DAN + Yael WEINSTEIN

Please make the following changes on the plan:

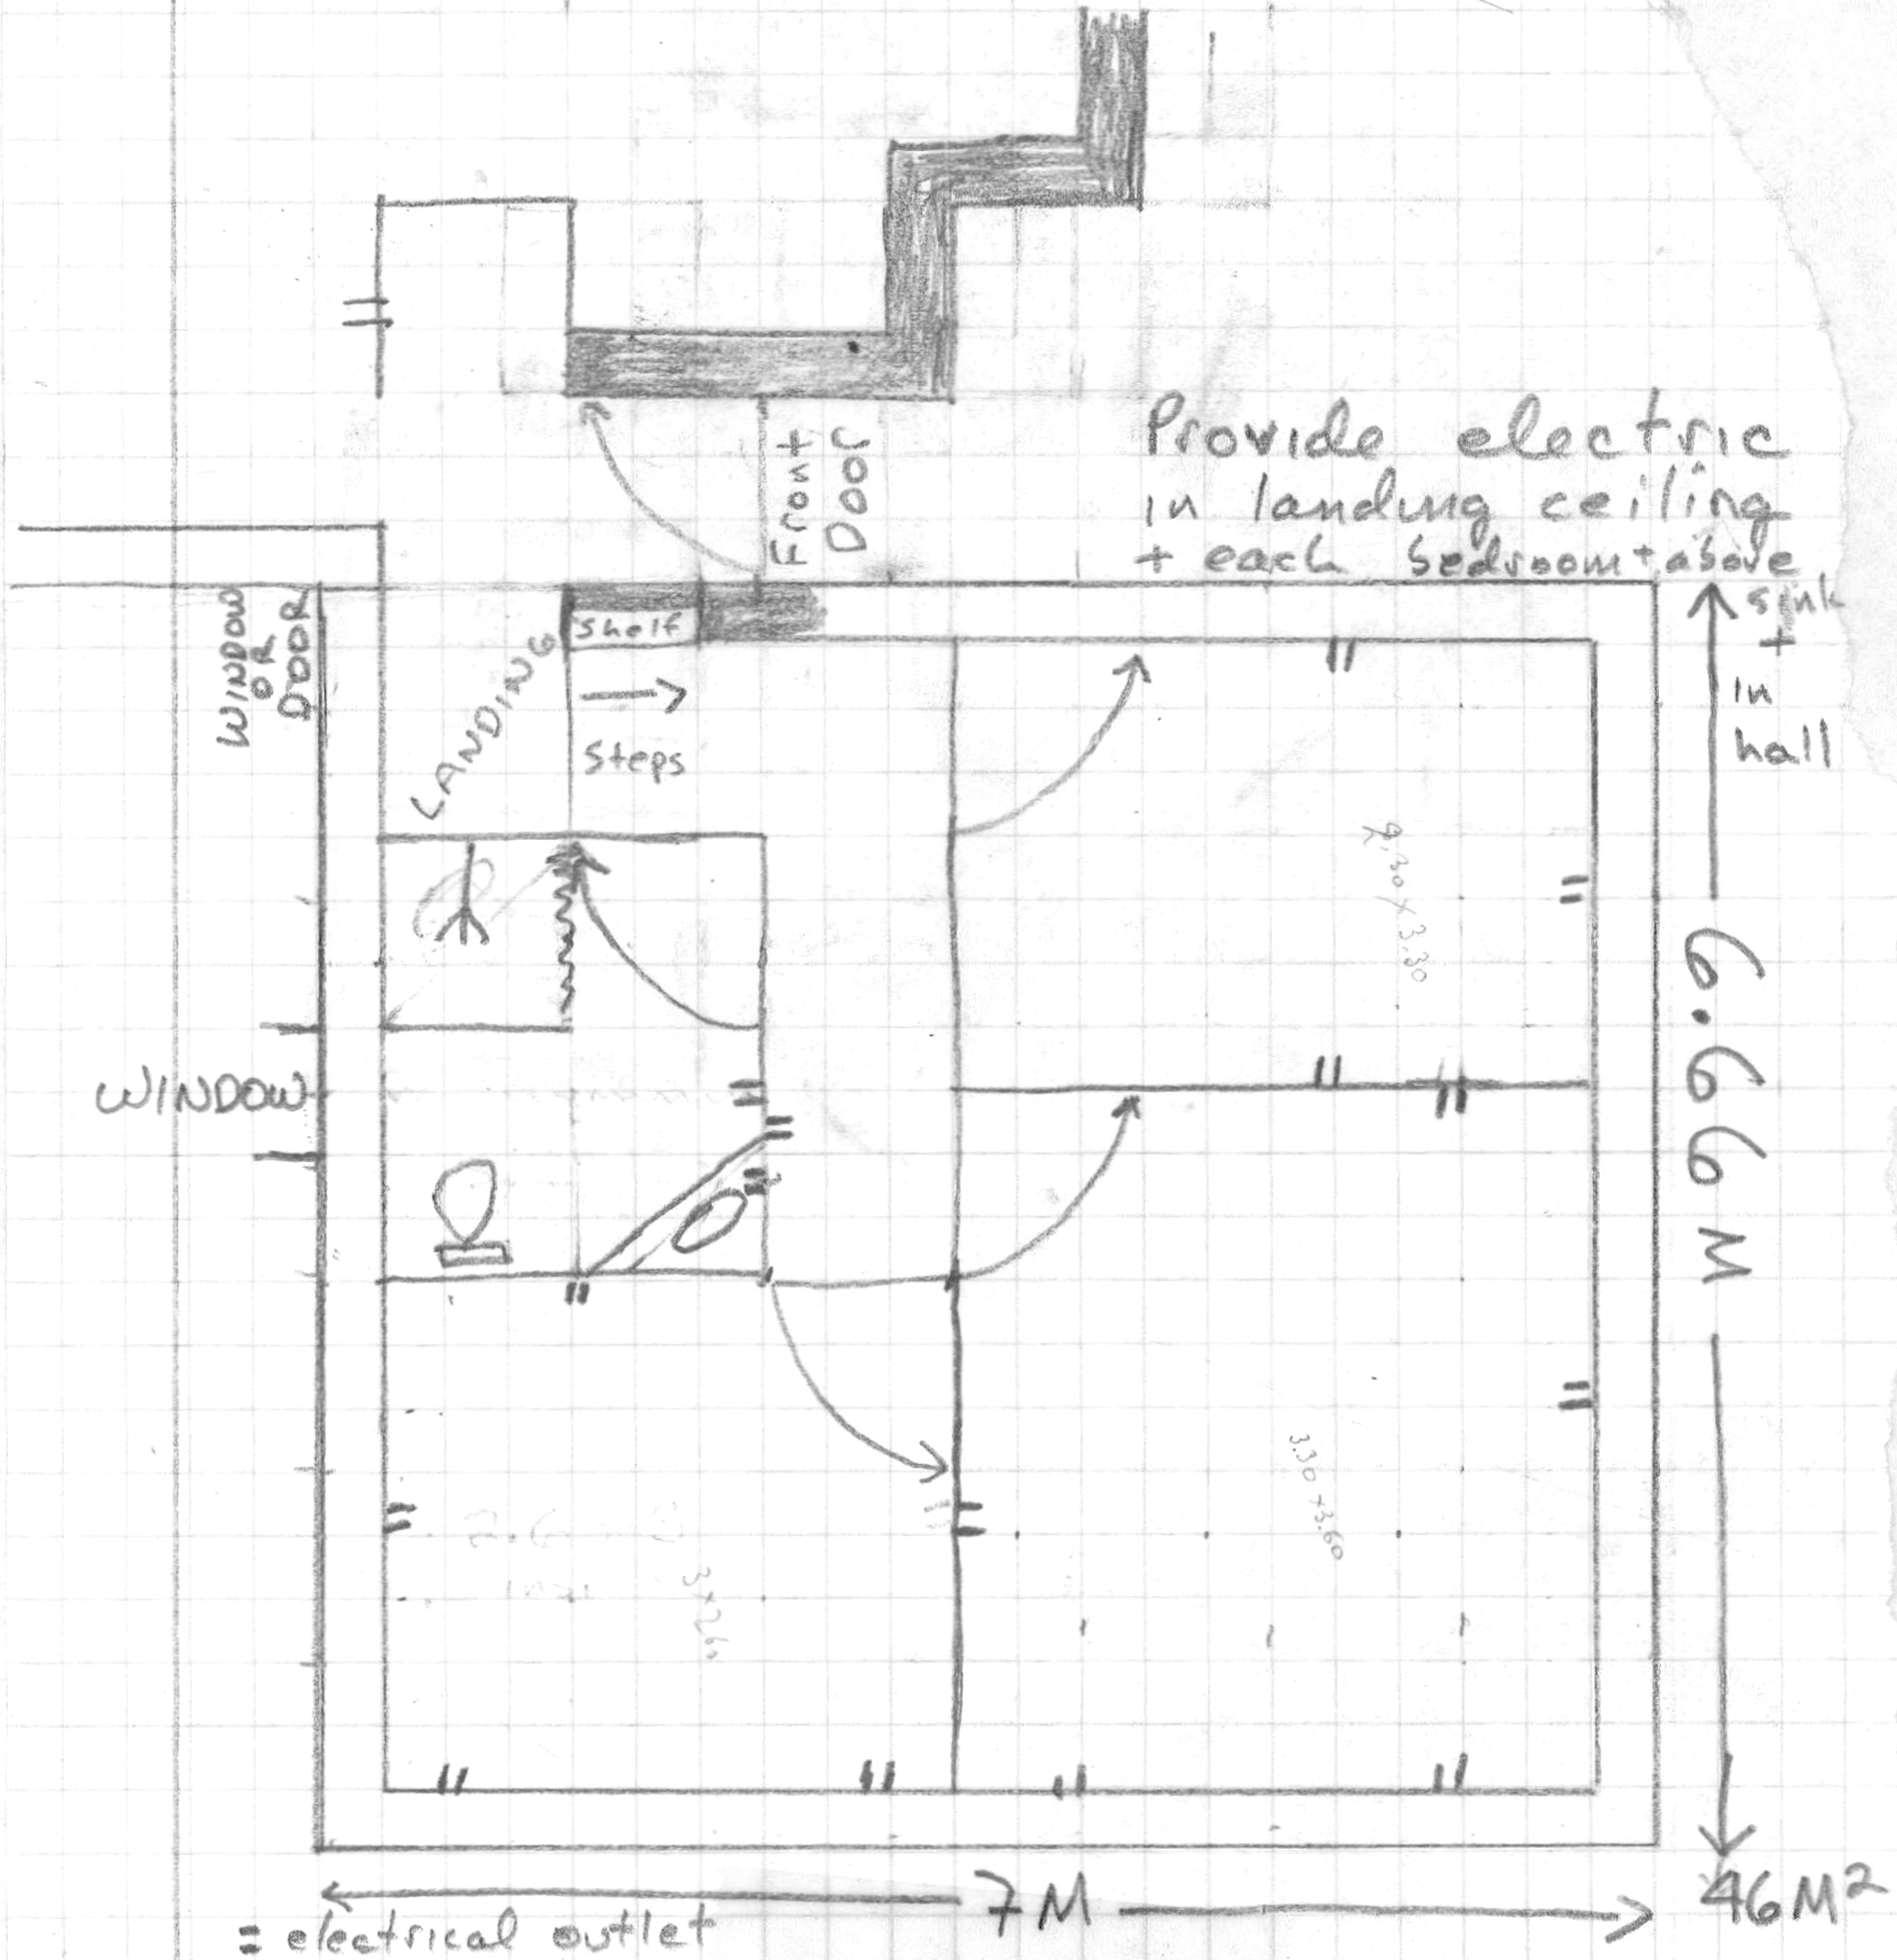
- eliminate door between entrance
hall and bedroom area.

change window and door from
living room to patio to
this configuration (MOVE DOOR TO
S.E. CORNER OF LIVING ROOM)

- change the bathroom window to a
small high window, (to avoid
direct view from patio.)
